NP-12-0026  
July 13, 2012

Subject: Exelon Nuclear Texas Holdings, LLC  
Victoria County Station Early Site Permit Application  
Response to Request for Additional Information Letter No. 18  
NRC Docket No. 52-042

**RAI 02.05.02-11:**

Figure 1a Houston demonstration site 10 Hz hard rock hazard curves: comparisons of several source models.

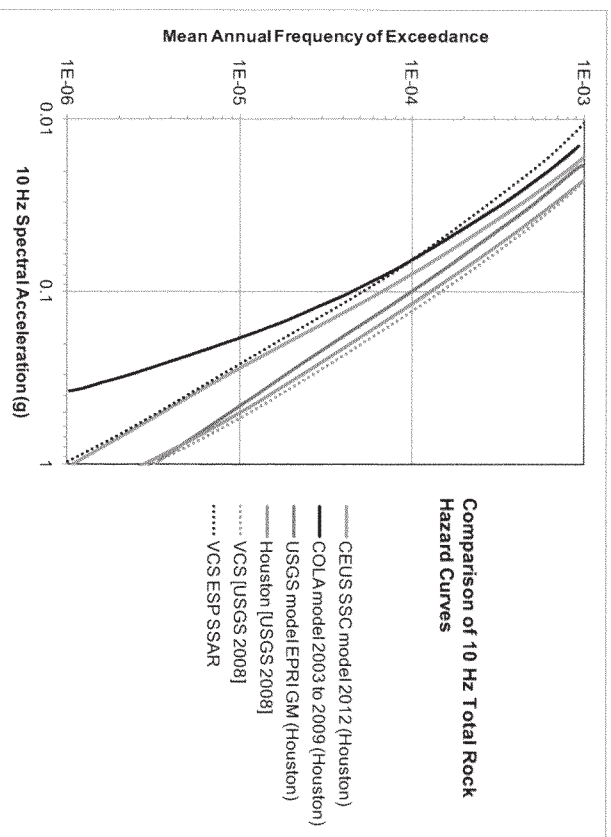
- a) Evaluate the potential impacts of the newly released CEUS-SSC model, with potential local and regional refinements as identified in the CEUS-SSC model, on the seismic hazard curves and the site-specific ground motion response spectra (GMRS). For re-calculation of the PSHA, please follow either the cumulative absolute velocity (CAV) filter or minimum magnitude specifications outlined in Attachment 1 to Seismic Enclosure 1 of the March 12, 2012 letter "Request for information pursuant to title 10 of the *Code of Federal Regulations* 50.54(f) regarding recommendations 2.1, 2.3, and 9.3, of the near-term task force review of insights from the Fukushima Dai-ichi accident." (Agencywide Documents Access and Management System Accession No. ML12053A340).
- b) Modify the site-specific GMRS if you determine changes are necessary given the evaluation performed in part a) above.

The three panels of Figure 1 show comparisons of mean hard rock hazard curves from several source models for 10 Hz, 1 Hz, and PGA response spectral accelerations. The heavy solid lines (from Figures 8.2-3j, 8.2-3k, and 8.2-3l of NRC, 2012a) compare hazard at the Houston, Texas, demonstration site for the current CEUS SSC source model (heavy red line), the USGS model developed for the National Seismic Hazard Mapping Project (Petersen et al., 2008) (heavy bright green line), and a "COLA" model (heavy black line) that has been used for nuclear power plant licensing applications between 2003 and 2009. According to the CEUS SSC report, the "COLA" model is the EPRI-SOG (EPRI, 1988) model updated with more recent characterizations for the New Madrid fault source, the updated Charleston seismic zone, and an update of maximum magnitude values for some seismic sources near the Gulf of Mexico to reflect recent seismicity. Additional details of this "COLA" model are not available in the CEUS SSC report (NRC, 2012a). Calculations of hazard for all three of these models use the EPRI (2004, 2006) ground motion prediction equations (GMPEs) so that the differences in hazard presented among the three models are attributable to differences in the source models themselves.

Also shown in each of these three panels are three additional mean hazard curves that have been included as part of this RAI response. The two olive green lines are hazard curves for the Houston (solid) and the VCS (dotted) sites from the USGS source model and USGS GMPEs. The difference, then, between the solid olive green and solid bright green hazard curves should arise from GMPE differences [EPRI (2004, 2006) vs. Petersen et al. (2008)]. The difference between the two olive green lines [solid and dotted] arises from their different locations within the USGS model.

The third additional line (dotted black line) in each panel is the hard rock VCS ESP SSAR hazard curve for that frequency. Since both the black dotted and heavy black solid hazard curves use the EPRI (2004, 2006) GMPEs and both use updated versions of the EPRI-SOG model these two lines might be expected to match each other closely. This is the case, in fact, only for the 1 Hz hazard curves. The reasons for the differences for the hazard curves at higher frequencies are unknown – and pertinent additional details of the "COLA" model are not available in the CEUS SSC report (NRC, 2012a) -- but could be caused by details of the geographic distribution of local seismic activity rates and/or difference in lower bound magnitudes used in the two analyses.
